### GOVERNMENT OF INDIA NORTH EASTERN COUNCIL SECRETARIAT NONGRIM HILLS, SHILLONG – 793003

Subject: Forwarding of Inspection Report.

## Report of the inspection carried on 16/11/2017 for the NEC funded project "Construction of G+4 building for Skill Development at Ramkrishna Mission ,Vivekananda Cultural Centre,Ramakrishna Misssion ,Quinton Road Shillong"

View of electrical board

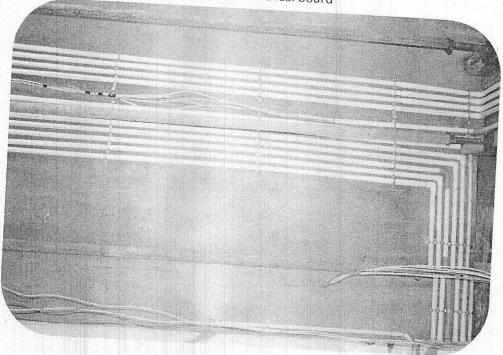
- Electrical works was not done according to the electrical standard and many anomalies were found.
- It was found that only one distribution board was installed for each floor. But according to the guidelines

SI.No.	Scope of Work as per DPR	Total amount to be spent	Remark
1.	G+4 building for skill Development at Ramakrishna Misssion, Vivekana nda Cultural Centre, Quinton Road, Shillong.	Rs. 31143632.00	a) Civil Works:-  The consultants had inspected the site and found the Structural parts of the building had been completed and finishing works such as tiles, aluminum works, granite works, applying of putty, plastering works were in progress. The Consultants had measured the plinth area of the building and it was found to be same as per area mentioned in approved DPR. The size of the columns a site was 350mm x 600mm whereas in DPR it was 350mm x 500mm. The consultant could inspect only the reinforcement used in C40 and C36 because the rest of the columns were already covered by plain cement concrete. The reinforcement used for C40 and C36 were 4nos. of 25mm dia bars and 10 nos. of 20mm dia bars which was more than the specification mentioned in DPR.  b)Electrical Works:-  It could be seen that Electrical conduiting of the whole building almost completed but wiring system was not done according to the electrical standard and many anomalies were found.  It was found that only one distribution board was installed for each floor. But according to the guidelines each floor should have separate LDB, PDB and UPS DB.  During inspection it was found that in distribution board implementing agency was using higher rating MCB for Lighting Circuit. Each lighting circuit should have load of maximum wattage of 800 watt and it should be connected to 6 amp or 10 amp.MCB not 20 AMP.MCB, as it was used.  It was also found that for Power Point, implementing agency was using looping

instead of per point basis and it was found that two power points were connected with a single power cable. Per Power point should be connected directly from PD and it should be connected to 16 AMP. Power MCB.  During inspection it was found that in power line, for earthling implementing agence was using 1 sq.mm cable instead of 1.5 sq.mm cables.  It could also be seen that colour coding for wiring was not maintained properly.  Inspection team also found that main power line which was going from one floor to another was going by wall mounted conduits not through G.I. Cable Tray with insulator and in every floor it was found that all power cable was going through cast iron made structure but not through G.I. Cable tray.
			<ul> <li>During inspection proper conduit layout, Circuit diagram, total load chart for each floor was not found.</li> <li>In the DPR, it was found that no electrical drawing was provided during the time of approval so that it was advised to provide proper electrical drawings per floor wise, main panel drawing, fire fighting system drawing with panel, CC TV line diagram for better execution of the project now.</li> <li>For smooth functioning and long lasting of highly sophisticated item proper earthing is needed for the whole building so it was suggested to the implementing agency to submit load calculation of each floor and room wise so that good earthling could be provided maintaining the electrical standard.</li> <li>It was also suggested to provide Lightening Arrestor on the top floor of the building for safety of the building from lightening in future maintaining appropriate electrical standard.</li> </ul>

- Concerned sector may ask for the rectification of the above mentioned anomalies from the implementing agency, which is very much necessary for smooth functioning and long lasting of highly sophisticated item which will be procured and installed and also to avoid any future disaster i.e. from electrical point
